# UNITED STATES PATENT AND TRADEMARK OFFICE

APPLICATION NO.	FILING DATE	FIRST NAMED INVENTOR	ATTORNEY DOCKET NO.	CONFIRMATION NO.
10/602,210	06/24/2003	David B. Griep	066042-9326-00	2237

**Office Action Summary**

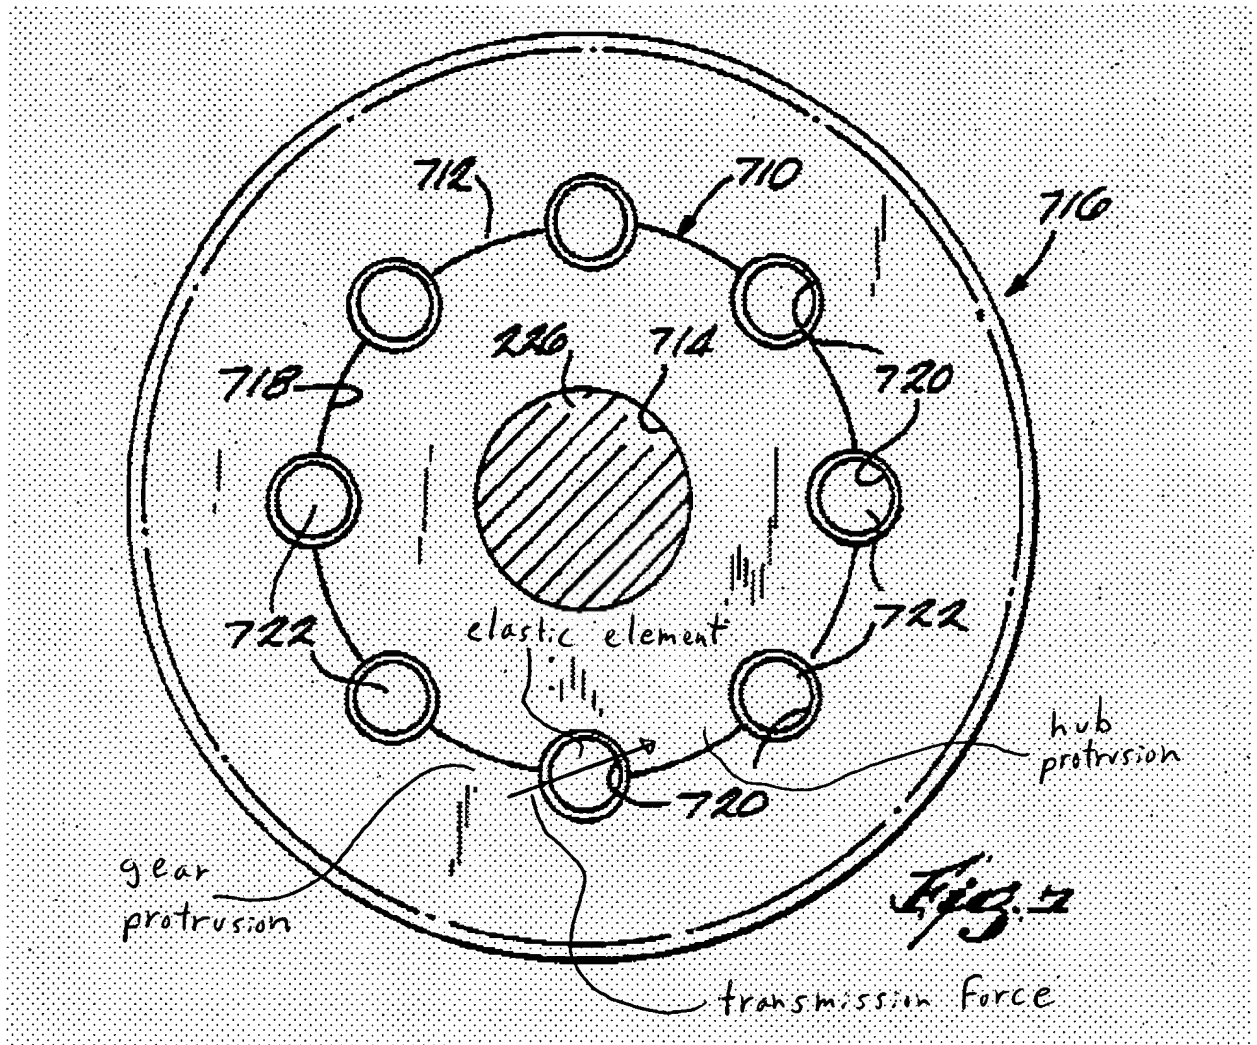
Applicant argues that Palm does not teach "*an elastic member positioned between the gear protrusion and the hub protrusion*". This is incorrect as seen in Palm's figure 7. The elastic element (722) is between the gear protrusion and the hub protrusion along a line of force transmission, as seen herebelow.
